Ratcliff Constructors, LP 4200 Beltway Drive Addison, Texas 75001 Phone: (972) 432-9969 Fax: (972) 432-9943 Project: 21-501 - Collin County Adult Detention Facility, Phase 1 Addition 4300 Community Avenue McKinney, Texas 75071

Prime Contract Potential Change Order #082: RFI #236 Upsize Elevator Breaker to 100A

RFI #236: Elevator Disconnects and Breakers/Fuses Needed

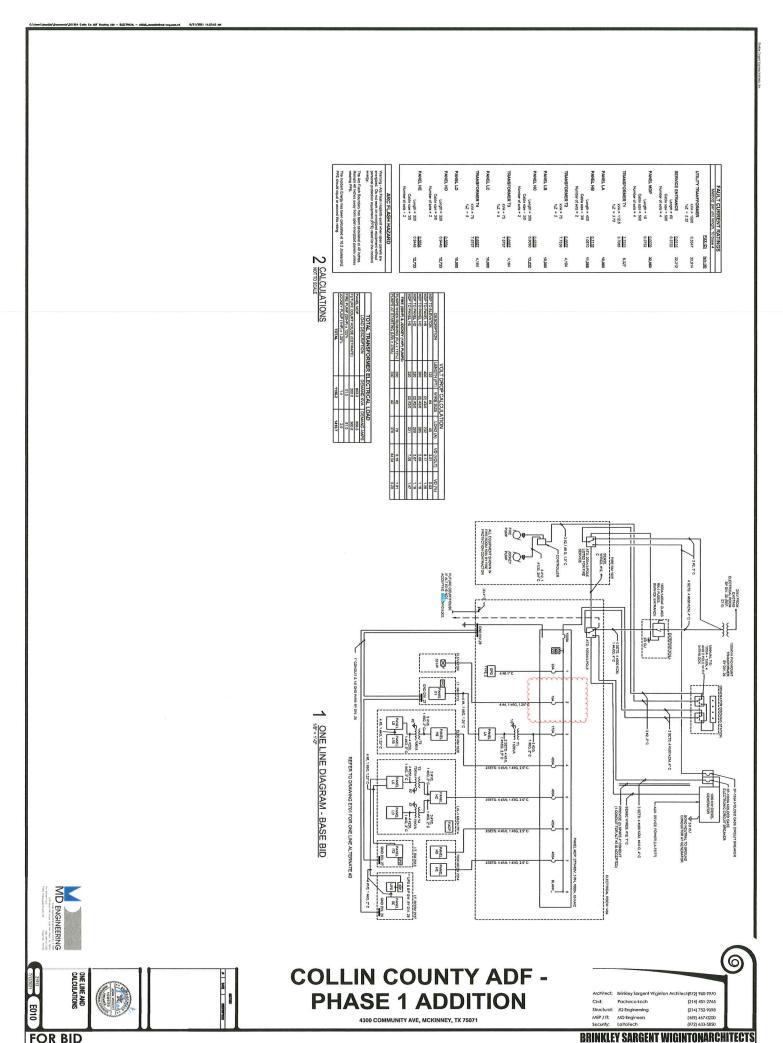
Per Otis Elevator, they will require 2 fused disconnects for the elevator. 1 is a 480v that we need to know the size for disconnect and fuses, and 1 is a 120 we know that is just a lockable with 20A fuses. Please provide fuse and breaker sizes.

PER ONSITE MEETING WITH MD ENG. 1/10/24, JASON AGREES 100 BREAKER IS NOT SHOWN IN THE CONTRACT DOCUMENTS. REFERENCE E010/1.

MD has not received a submittal for the elevator:

Per the Electrical Drawings.

30HP / 480V= 40amps X 2.5 = 100A disconnect and fuses.

Before ordering the discornect, contractor to verify the submitted elevator is 30HP.
